15 E. HARVARD ST. REPLAT

SUMMARY

Updated: May 29, 2014

Minor Plat request to subdivide the property into 3 lots.

PROPOSED PLAT

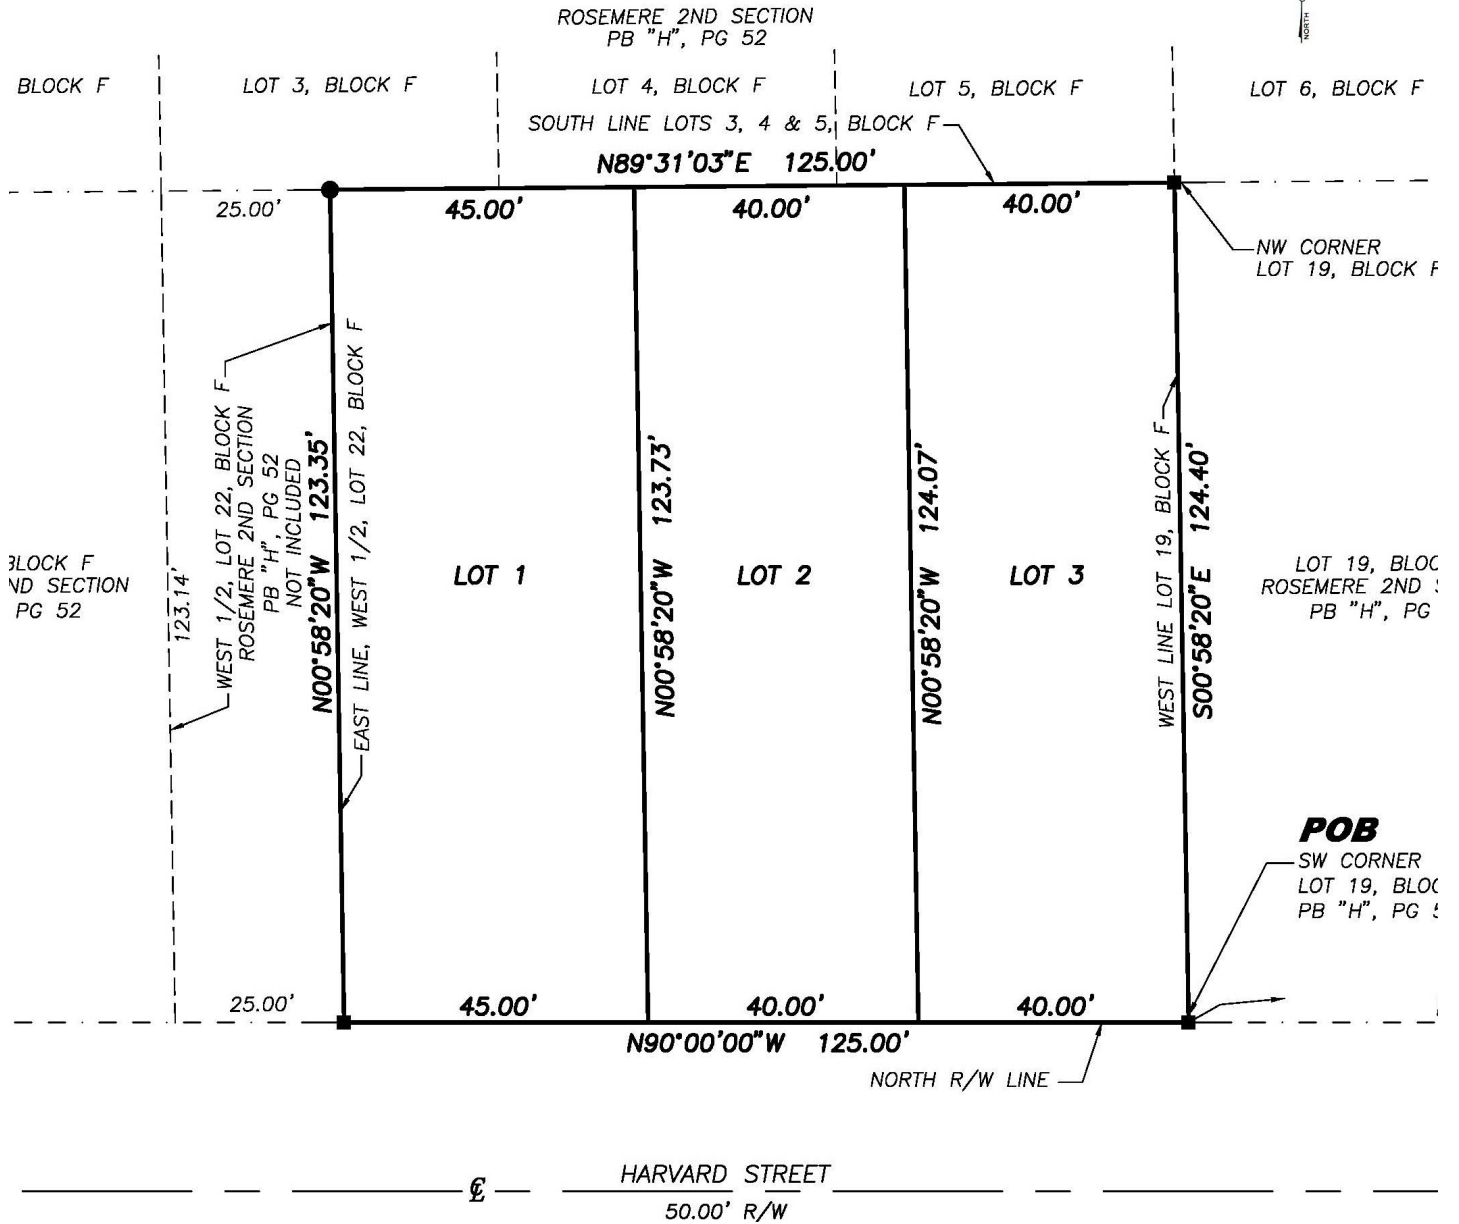
3) The legal description shown on the plat must be the same in form and content as the legal description shown on the title opinion/certificate.

4) Any easements that appear on the title opinion/certificate must be depicted on the plat or referenced in the plat notes.

3. Easement Dedication. Per Orlando Land Development Code (LDC), Chapter 61, Figure 5, the required right-of-way (R-O-W) setback from street centerline for any residential street is sixty (60) feet, or fifty (50) feet plus a 5 ft. wide City Services Easement. The existing R-O-W from street centerline for E. Harvard Street is fifty (50) feet. The owner/applicant shall dedicate five (5) feet of City Services Easement for the length of the property along E. Harvard Street to meet LDC (Section 61.260)

6. Plat-Minor. Plat Face Changes - There are a number of changes required to the face of the plat. In addition to the changes required on the plat, the following is a list of additional requirements.

1)Changes to the face of the plat.
